Better Contract Oversight Could Have Prevented  
Deficiencies in the Detention Facility in  
Parwan, Afghanistan

SUBJECT: Better Contract Oversight Could Have Prevented Deficiencies in the Detention Facility in Parwan, Afghanistan (Report No. DODIG-2012-089)

**Figure 1. Examples of Poorly Welded Cell Grates**

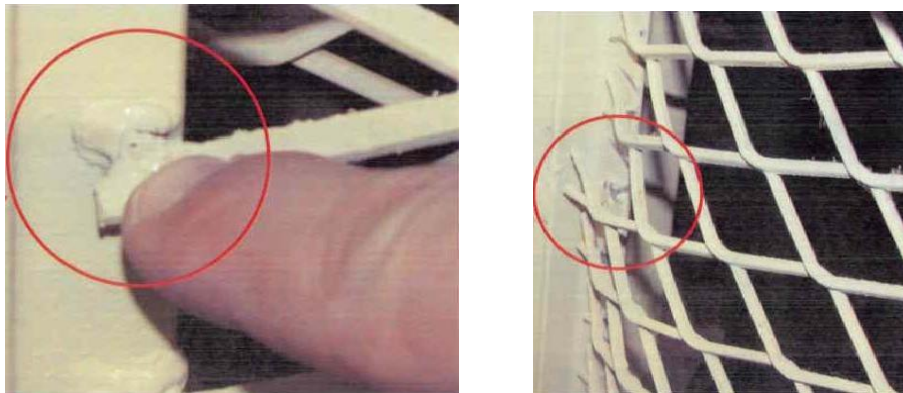
Cell doors were poorly constructed and hung with incorrect hinges, and access doors were missing the magnetic sensors and electronic locks. The contract called for the cell doors to be extra heavy duty, factory fabricated in accordance with American National Standard Institute A250.8 and National Association of Architectural Metal Manufacturers/Hollow Metal Manufacturers Association standards. Based on those standards the cell doors should have had welded frames and full-mortise heavy duty hinges complying with American National Standard Institute/Builders Hardware Manufacturer Association 156.1, spaced appropriately with a minimum of three hinges per door. The cells were to have a wire cage on the front and the doors equipped with all required commercial quality tamper proof hardware complying with applicable portions of American National Standard Institute /Builders Hardware Manufacturer Association standards A156 through A156.24 including closers on personnel doors of Series C02000, Grade 1 adjustable surface mounted type in accordance with American National Standard Institute /Builders Hardware Manufacturer Association Standards A156.4.

In a Construction Quality Presentation in July 2010, Task Force Rocky Mountain officials stated that the construction quality was not up to the standard suitable for a detention facility, and that the quality of construction of greatest interest was the areas where the detainees spent most of their time such as detention cells and the recreation yard. The presentation went on to say that the poorly constructed cell doors allowed detainees to damage the doors easily by repeated kicking. Figure 1 shows examples of the poor welding and Figure 2 shows the damage to the cell doors caused by the detainees because of the poor construction.

*The poorly constructed cell doors allowed detainees to damage the doors easily by repeated kicking.*

**Figure 7. The Electrical System Panel (left) and Explanation of the System (right)**

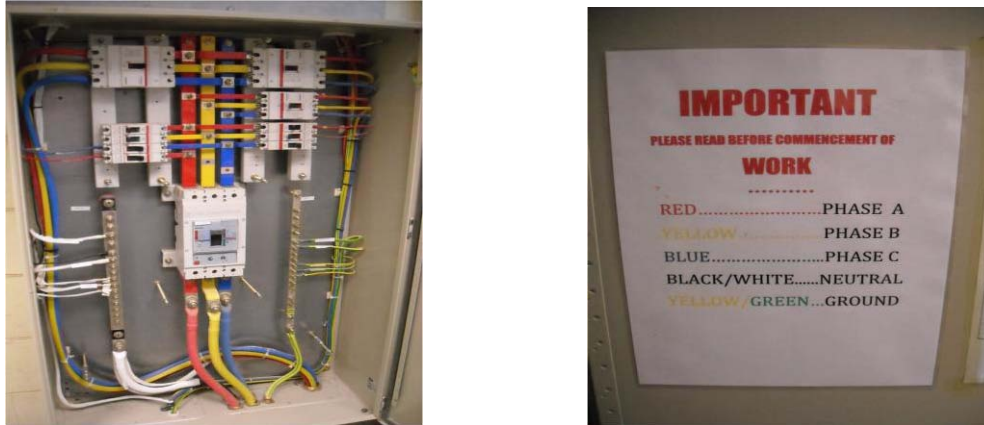
*Distinct differences exist between the U.S. and British standards, especially regarding grounding, bonding, and wiring conventions.*

Personnel who had experience with the British Standard installed the British Standard electrical system during construction, and posted the explanation of the British Standard inside the electrical panels (see figure 7 [right]).

Continued failure to correct the electrical code violations increases the risk of loss of service and the potential of the loss of life for anyone attempting repairs.

Comment: USACE has previously advised that the electrical system was built to US standards with some British equipment. However, the report states that the system is built "primarily to British standards" and that this was done without approval. The voltage system for the DFIP is US (60 Hz) while the color coding in place is British due to the British materials used for this project. It should also be pointed out that even if the system were built to British standards, this would still be in accordance with USFOR-A policy and USACE Transatlantic Division guidance.

Comment: This statement appears to be based on a USACE deficiency report from June 25, 2010, however all grounding and bonding issues were subsequently corrected under warranty.

**Figure 4. Contractor trucks removing sewage from DFIP lift stations.**

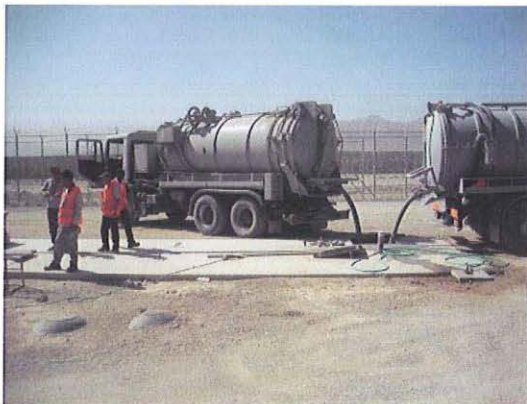
Since the two lift stations are inoperable the sewage began to solidify because the non-waste-related materials flushed down the sewage system are too large and cannot pass through the lift station pumps. With the solid sewage and other items remaining in the two lift stations, the sewage begins to harden. Once the sewage hardens inside the lift station, it causes the waste level to rise above the sewage lines leading from the DFIP buildings as well as the outlet lines that should be used to transfer the sewage to the collection point. On September 3, 2010, Fluor notified TF Peacekeeper that the underground sewage system was rapidly approaching the point to where it will need to be shut down. As of October 25, 2010, lift station number 1 is back online. USACE and PPI are working on a temporary solution for lift station 2. According to USACE personnel the corrections to the two lift stations will help eliminate the need for pump trucks.

To prevent the two sewage lift stations from overflowing, Fluor must bring four sewage removal trucks (see Figure 4) a day into the compound. Because the DFIP is a secure location, every time the trucks have to enter the facility the risk of a security incident increases.

To maintain the health and security of the individuals working and housed at the DFIP, USACE AED-N should require the contractor to immediately repair the lift stations in accordance with the warranty provisions in the contract and ensure the lift stations meet the requirements set forth in the contract.
